February 24, 1994  
Fort St. Vrain  
ISFSI  
P-94018

Docket No. 71-9253

SUBJECT: Response to the NRC's Request For Additional  
Information Regarding the Model No. TN-FSV Packaging

**PSC RESPONSES TO NRC QUESTIONS ON THE  
TN-FSV IRRADIATED FUEL SHIPPING PACKAGING**

Figure 1  
FSV Operating History

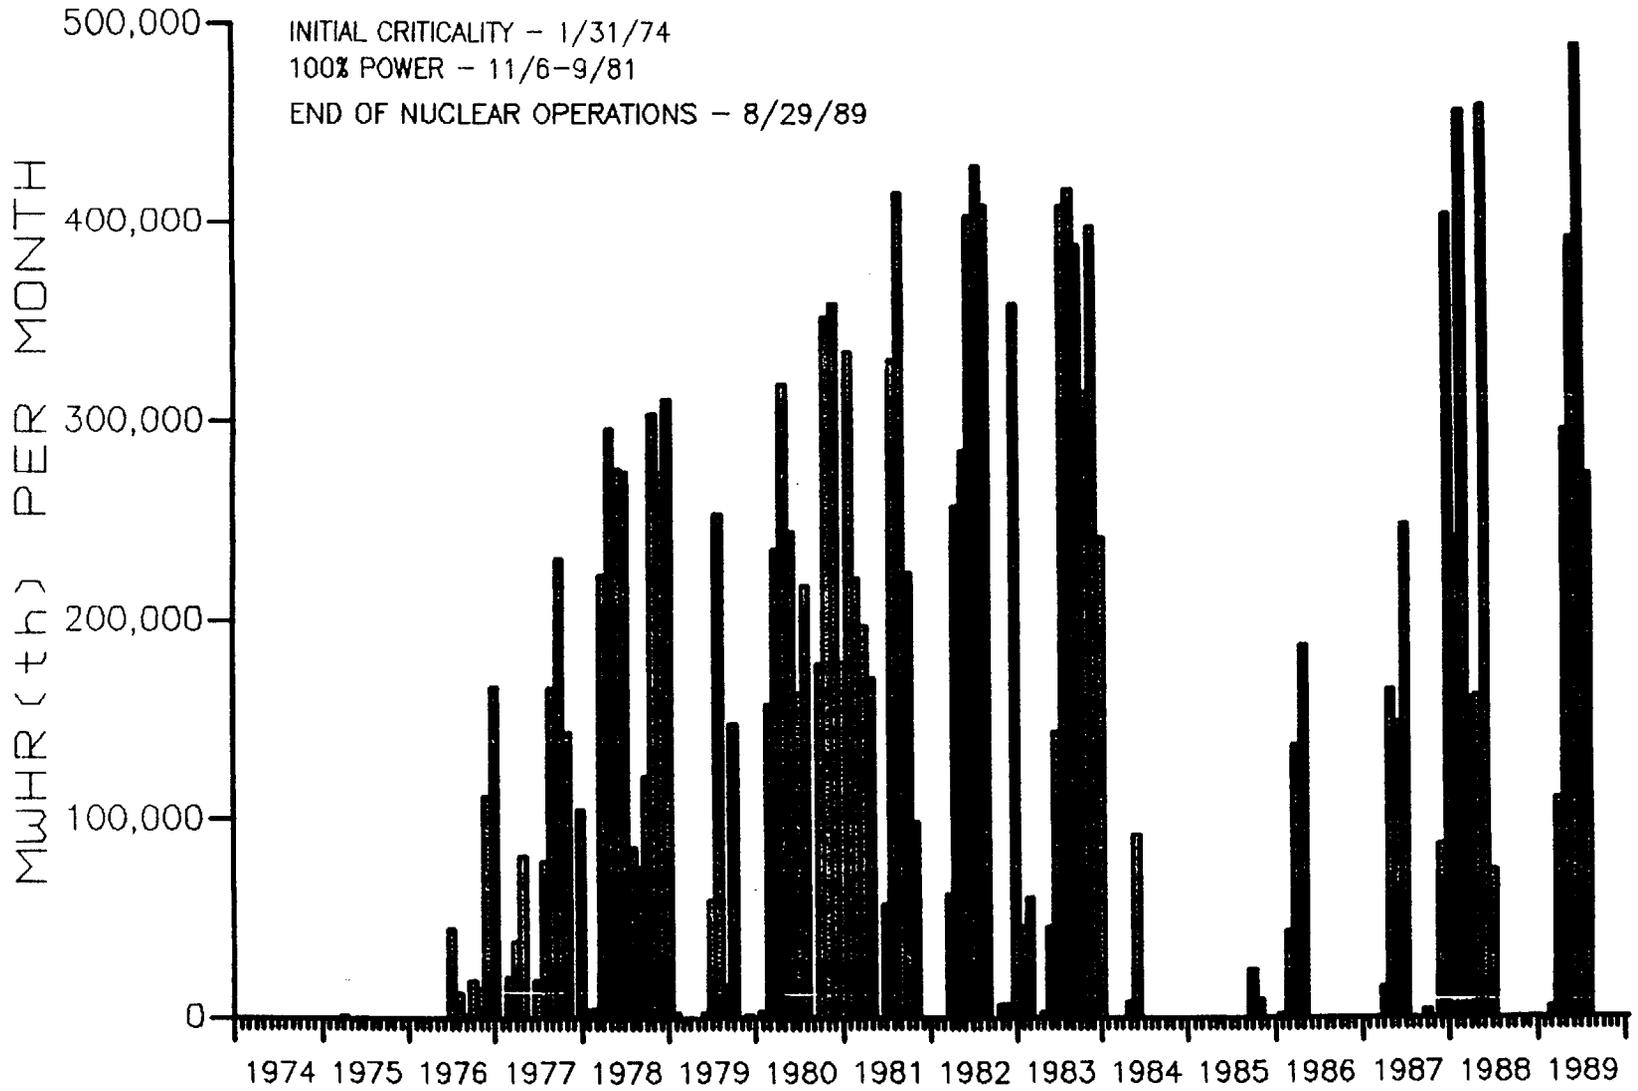
Specify the fuel parameters (e.g., isotopic composition, isotope masses, etc.) and fuel burn-up history (e.g. reactor power, number of cycles, up-time and down-time per cycle, etc.) that were used to determine the shielding source terms. Show that these parameters and burn-up history adequately represent the FSV fuel and provide the bounding source terms.

The operating history of the FSV plant was quite sporadic throughout its life. Therefore, modelling the actual power history was extremely difficult. Figure 1 summarizes the Fort St. Vrain operating history.

**FIGURE 2.10.3-1  
SIDE CRUSH TEST CONFIGURATION**

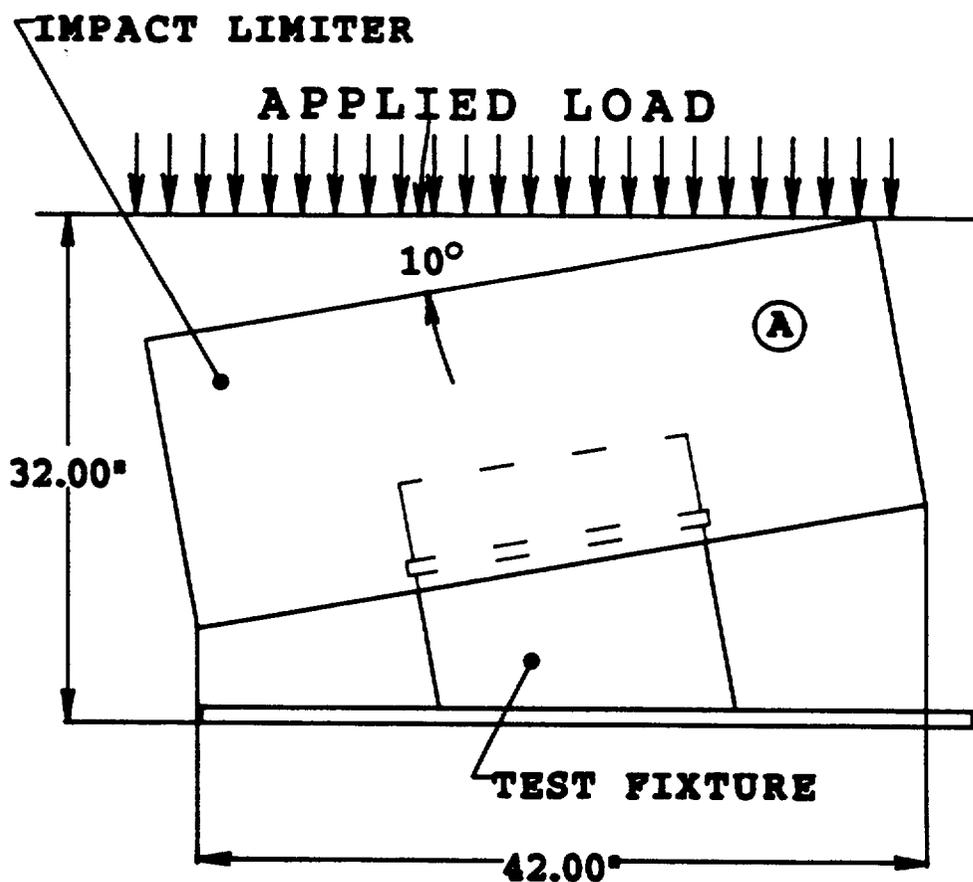
Revise the application to show that the impact limiters remain attached after the 30-foot drop and puncture tests.

During the side crush test, five of the six attachment bolts broke. The bolts broke after 81% of the energy needed for the side drop was absorbed. This was well above the energy to be absorbed by a single impact limiter in either a side drop (50%) or a shallow angle drop (68%), thus providing evidence that the impact limiters would remain attached after a 30-foot drop.

FIGURE 6-2

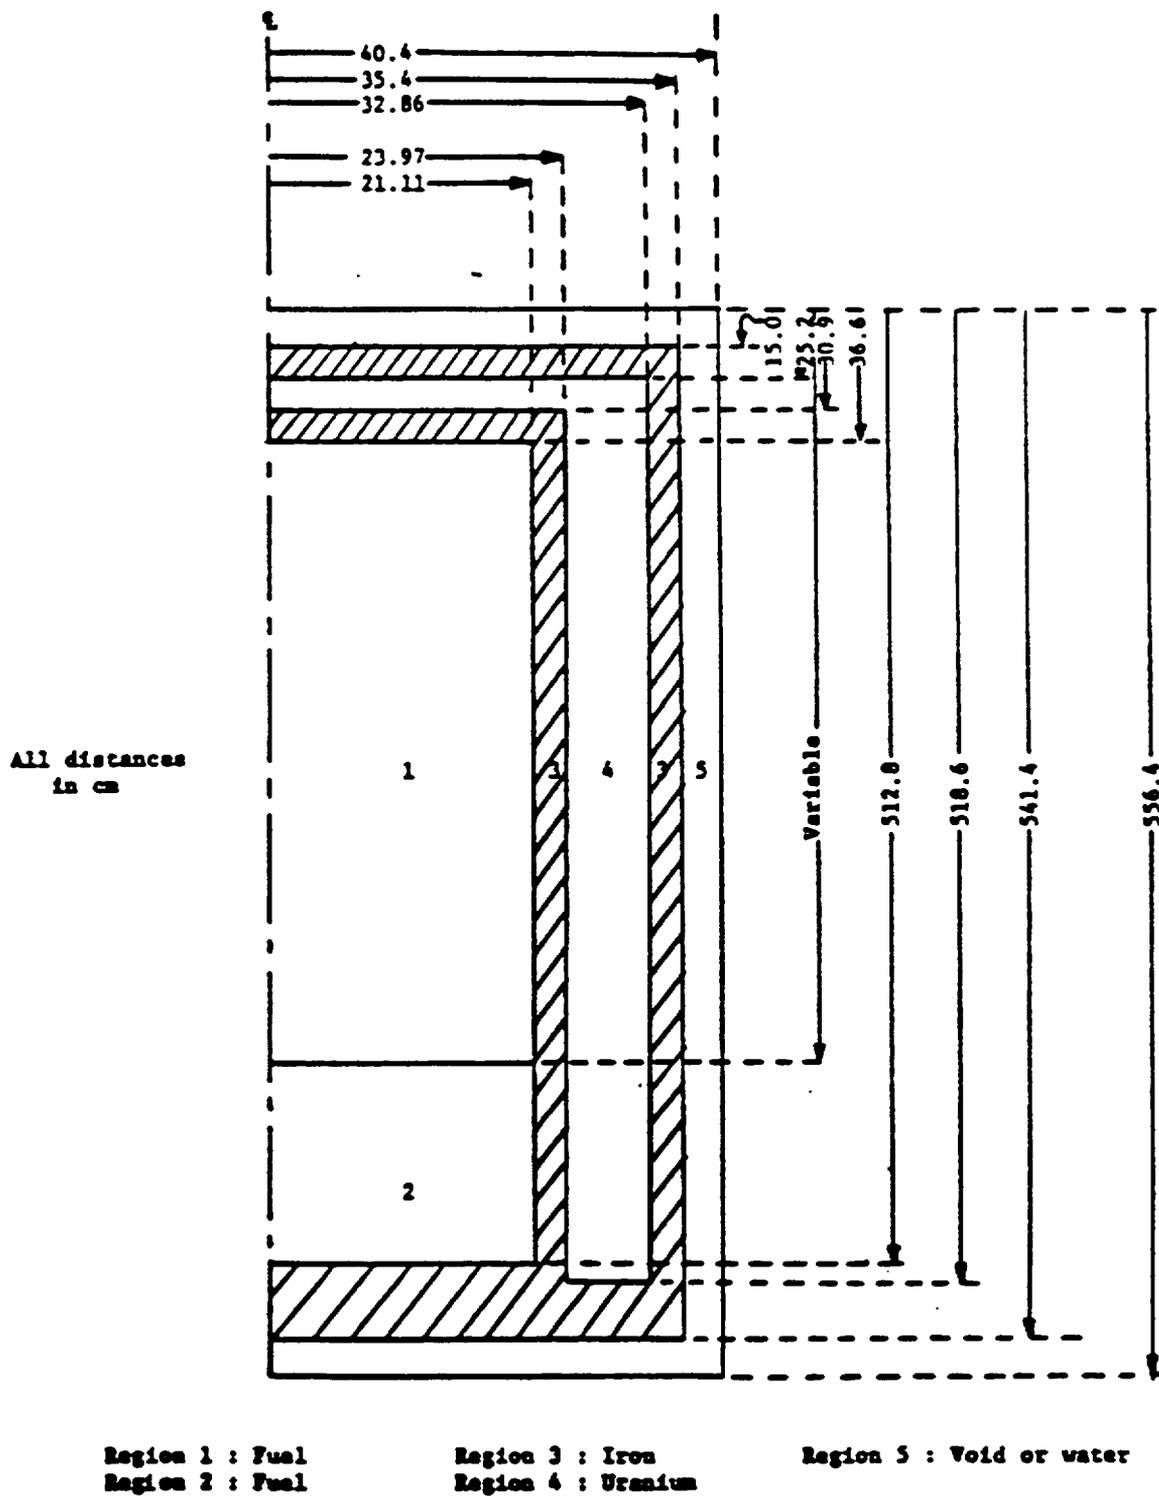
Provide the data that were used in the criticality computer programs in sufficient detail that the calculations can be repeated with an alternative computer code.

The material concentrations used for most reactive unflooded (Table 14) and flooded (Table 15) conditions are listed on the following tables. The region number corresponds to SAR Figure 6-2 and SAR text in section 6.4.2.a and 6.4.2.b.

- Notes:
- 1) Region 1 is the same number densities as in Table 14 but multiplies by 81.4%.
  - 2) Region 3 for the FSV-TN Cask is not depleted Uranium, but is lead, with an approximate number density of 3.30E-2 atoms/b-cm
  - 3) Radii for regions 3 and 4 for TN-FSV Cask are approximately 3" longer than those shown on SAR Figure 6-2 to increased thickness of lead.
